DRAFT UNR RDE

Section 1: Scope and application

Figure 2 - Definition of delay, rise, transformation and response times

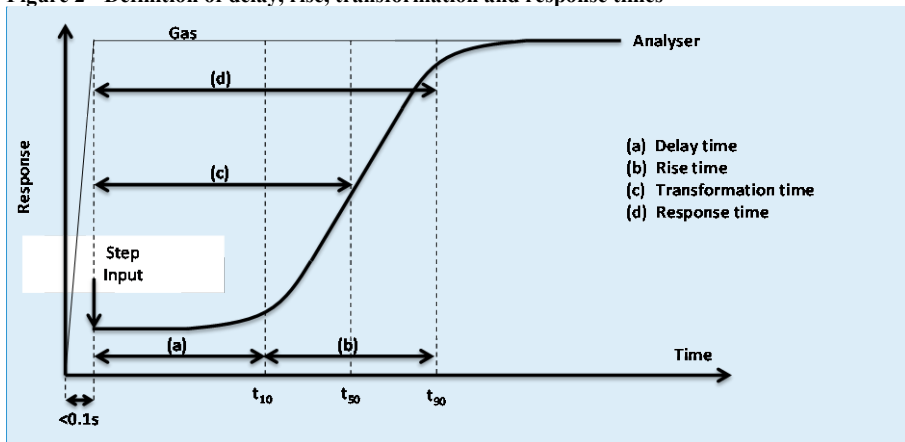
Commented [DP8]: Add T10 to T90 in figure

Commented [JRC-ISPRA5]: put t_0 in the figure
Important because the time alignment is based on t_0

Figure 1

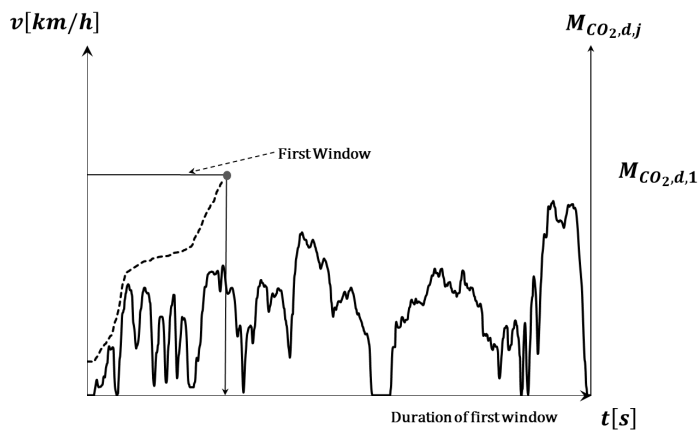
Commented [DP52]: JRC to check if reference should be made to 4-3 phases or ATCT corrections are needed...

Commented [M53]: Why did you delete ‘emission’ and add ‘vehicle average speed’ in RDE4 ?
